Browns Ferry Nuclear Plant, Units 2 and 3  
Facility Operating License Nos. DPR-52 and DPR-68  
NRC Docket Nos. 50-260 and 50-296

**Subject: Technical Specification Change TS-429 – Deletion of Low Pressure Coolant Injection Motor-Generator Sets for Browns Ferry Nuclear Plant, Units 2 and 3**

### **EVALUATION FOR TECHNICAL SPECIFICATION CHANGE TS-429 Deletion of Low Pressure Coolant Injection Motor-Generator Sets for Browns Ferry Nuclear Plant, Units 2 and 3**

**Figure 1, Current Configuration of Portion of BFN, Unit 2, Electrical Distribution System Associated with Proposed Change**

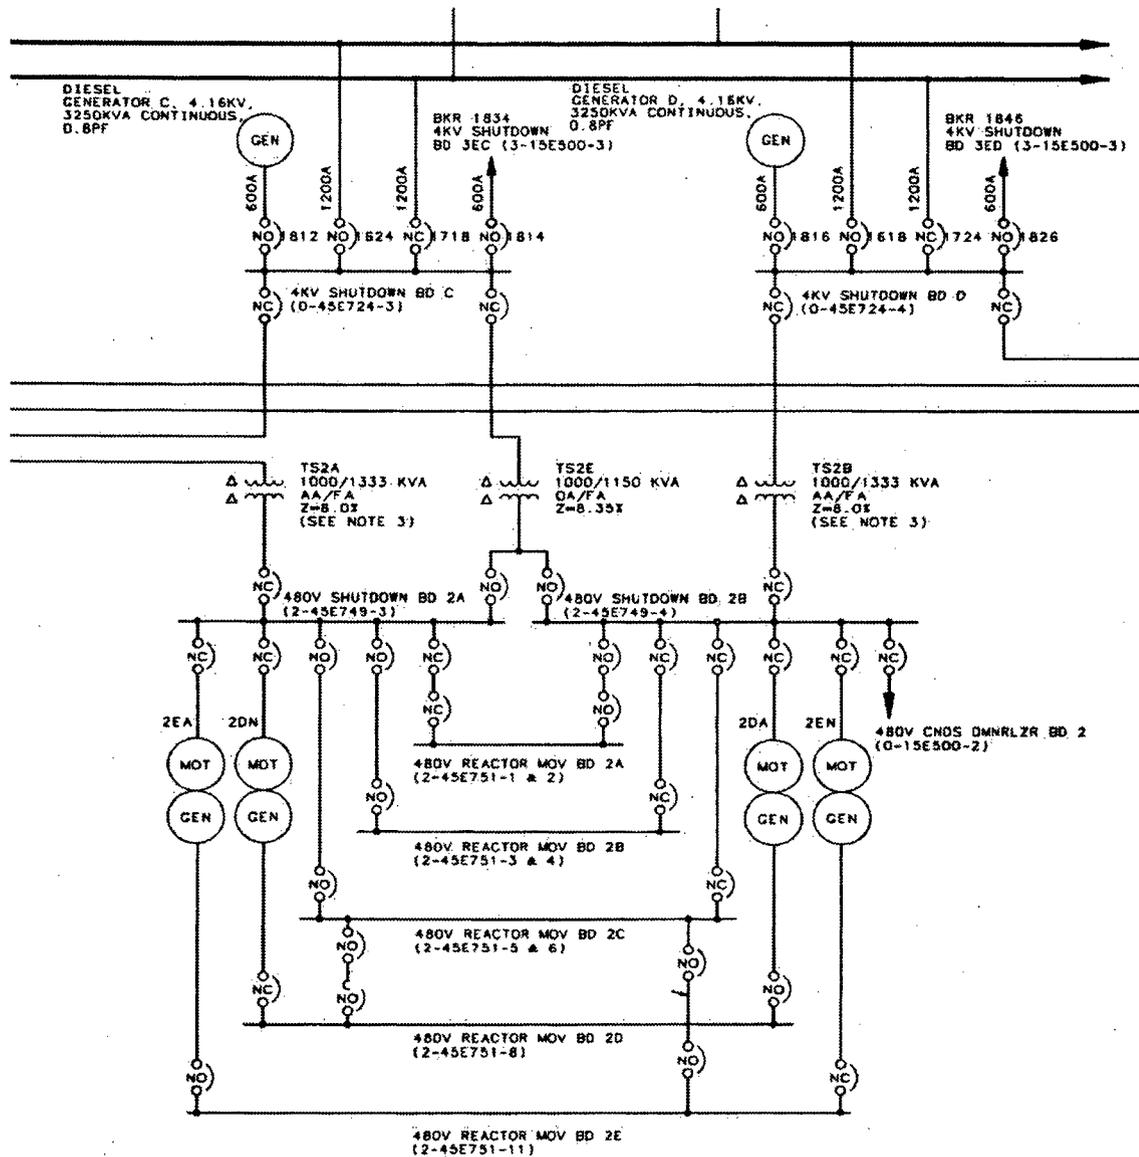
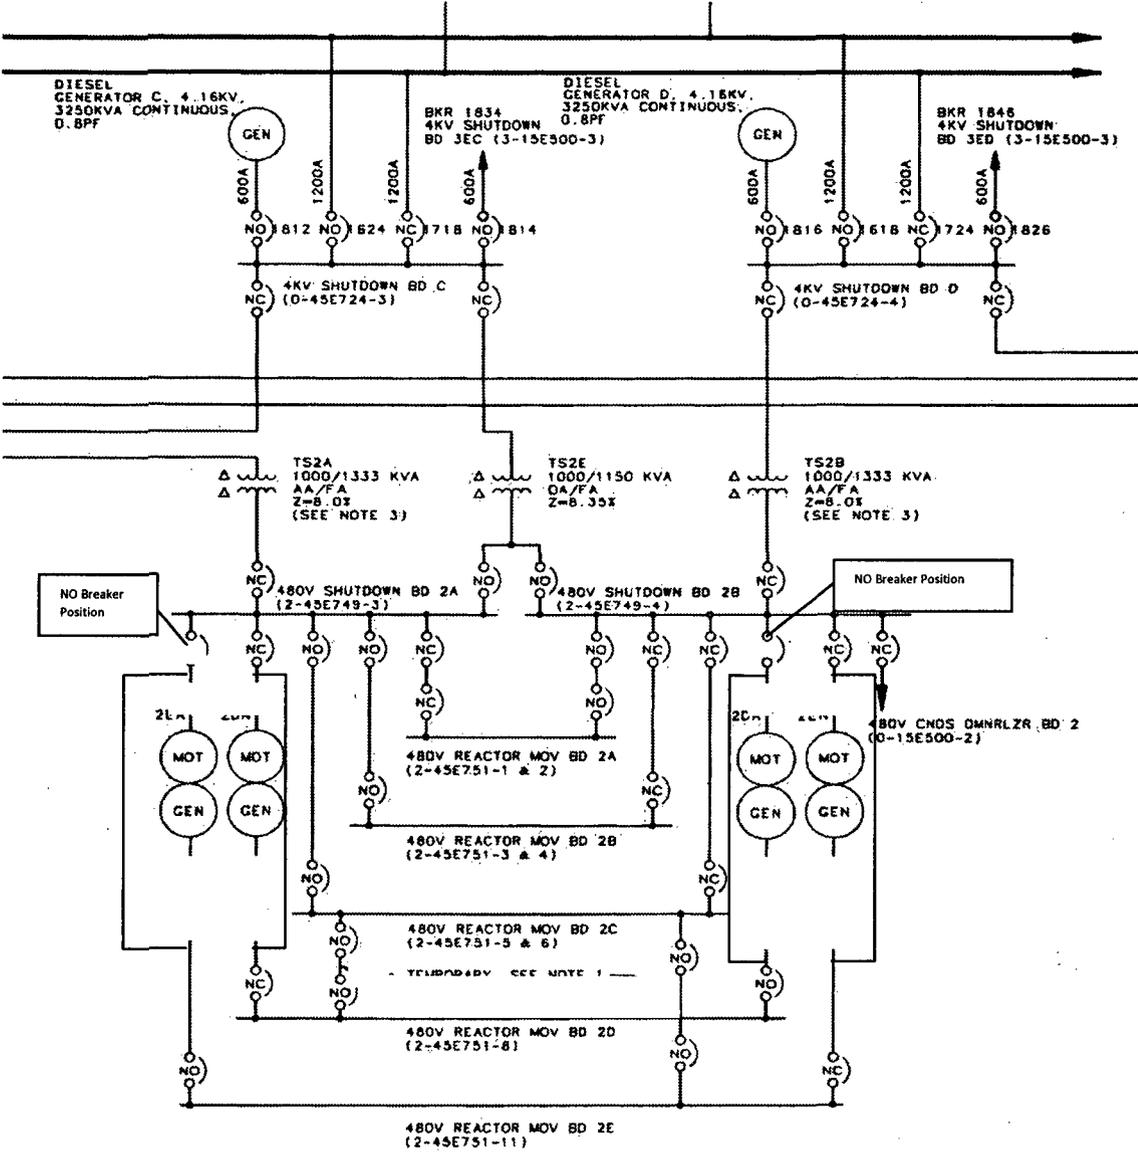
1. BFN, Units 2 and 3, LPCI MG Sets DN, DA, EN, and EA and their locally mounted instrumentation and controls will be removed from service and abandoned in place.
2. Instead of RMOV Boards D and E being powered from the LPCI MG Sets, they will be powered directly from the corresponding 480V Shutdown Boards through their normal feeds.
3. The feeder breakers for 480V RMOV Boards D and E at the applicable 480V Shutdown Boards will be modified from electrically operated to mechanically operated.
4. The alternate feeder breakers for 480V RMOV Boards D and E at the applicable 480V Shutdown Boards will be changed from normally closed to normally open.

The current configuration of the portion of the electrical distribution system associated with this proposed change is shown in Figures 1 and 3 for BFN, Units 2 and 3, respectively.

After the proposed change, the resulting configuration of the portion of the electrical distribution system associated with this proposed change will be as shown in Figures 2 and 4 for BFN, Units 2 and 3, respectively.
